Project	IEEE 802.16 Broadband Wireless Access Working Group < http://ieee802.org/16 >	
Title	Enhancements to the Message Transfers for the initialization of Scan, Sleep, and Idle Mode	
Date Submitted	2004-11-05	
Source(s)	Yongwon Kwak, Kiseon Ryu, Beomjoon Kim, Yongho (Ronny) Kim, and Changjae Lee, LG Electronics Inc., 533, Hogue-1dong, Dongan-gu, Anyang-shi, Kyongki-do, Korea	Voice: +82-31-450-4387 Fax: +82-31-450-7912 [mailto:{yongwon, ksryu, beom, ronnykim, cjlee16}@lge.com]
Re:	Response to Sponsor Ballot	
Abstract	This document contains suggestions to enhance message transfers for initializing Scan, Sleep, and Idle Mode.	
Purpose	Adoption of proposed changes into P802.16e	
Notice	This document has been prepared to assist IEEE 802.16. It is offered as a basis for discussion and is not binding on the contributing individual(s) or organization(s). The material in this document is subject to change in form and content after further study. The contributor(s) reserve(s) the right to add, amend or withdraw material contained herein.

Enhancements to the Message Transfers for the initialization of Scan, Sleep, and Idle Mode

Figure 7. Wait for DREG-REQ – BS

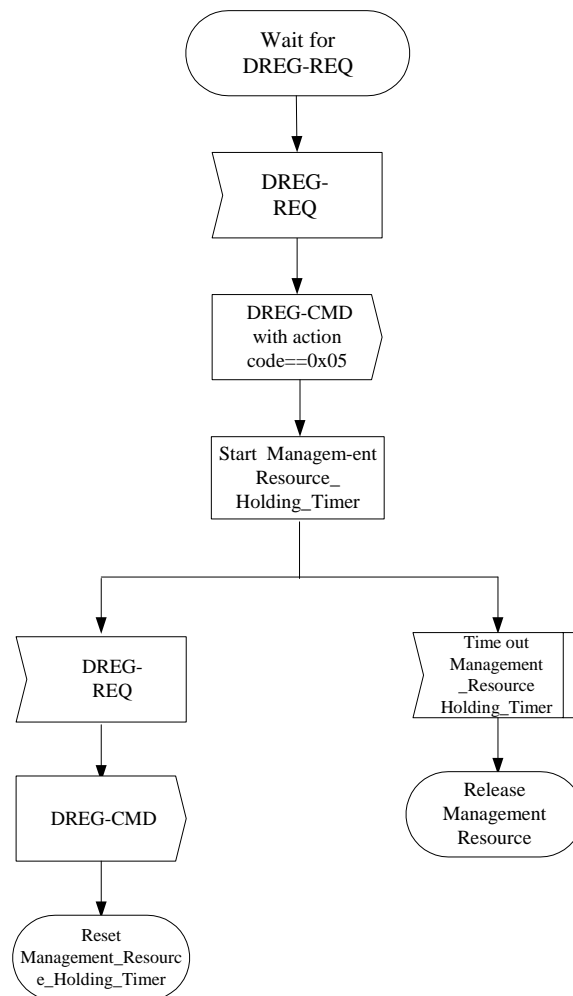
All good except we already have a system resource retain timer for DREG; don't need another.

→ I think a Management_Resource_Holding_Timer for DREG is different from resource retain timer, the reasons are following.

First, a resource retain timer is used to retain an MSS's information when the MSS does handover, but the Management_Resource_Holding_Timer is used to maintain the MSS's information when the MSS deregisters at Serving BS.

Second, during the MSS handover procedure, both an MSS and BS set resource retain timer as the same value via negotiation using REG-REG/RSP message, but in case of the MSS deregistration, the BS only sets a Management_Resource_Holding Timer, and the MSS sets a T32 timer to the different value.

Third, the Management_resource_Holding_timer shall be updated whenever the BS receives a DREG-REQ message from the MSS.

Due to the above reasons, resource retain timer and Management_Resource_Holding_

Timer should be implemented separately.

[In 6.3.19.1 Figure 130b-MSS Awaiting Sleep Response SDL Diagram, page 106, modify the following Figure as]:

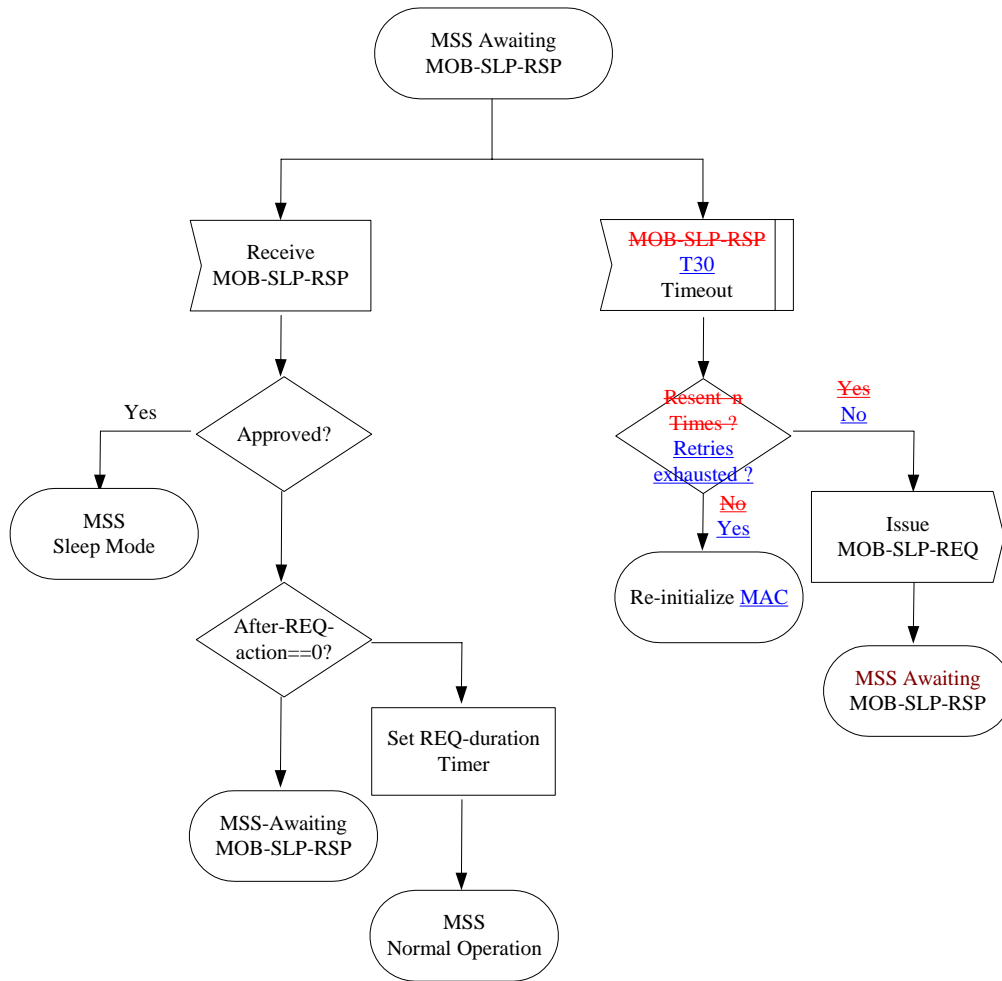
Add the text to describe the procedure to retransmit MOB-SLP-REQ message, while a retry count is not exhausted if an MSS sent a MOB-SLP-REQ message to a BS and didn't receive a MOB-SLP-RSP message within a specified time, and modify Figure 130-b.

Before entering Sleep Mode the MSS shall inform the BS using MOB-SLP-REQ and obtain its approval. The BS shall respond with an MOB-SLP-RSP message. If the MSS does not receive the MOB-SLP-RSP message within T30 timer expiry after it sends the MOB-SLP-REQ message to the BS-, the MSS shall retransmit the MOB-SLP-REQ message as long as retry count has not been exhausted. Otherwise, the MSS shall re-initialize MAC. The Serving BS may send an unsolicited MOB-SLP-RSP to the MSS to initiate MSS Sleep Mode. After receiving an approving MOB-SLP-RSP message from the BS, an MSS shall enter Sleep Mode at the appropriate frame prescribed by the message.
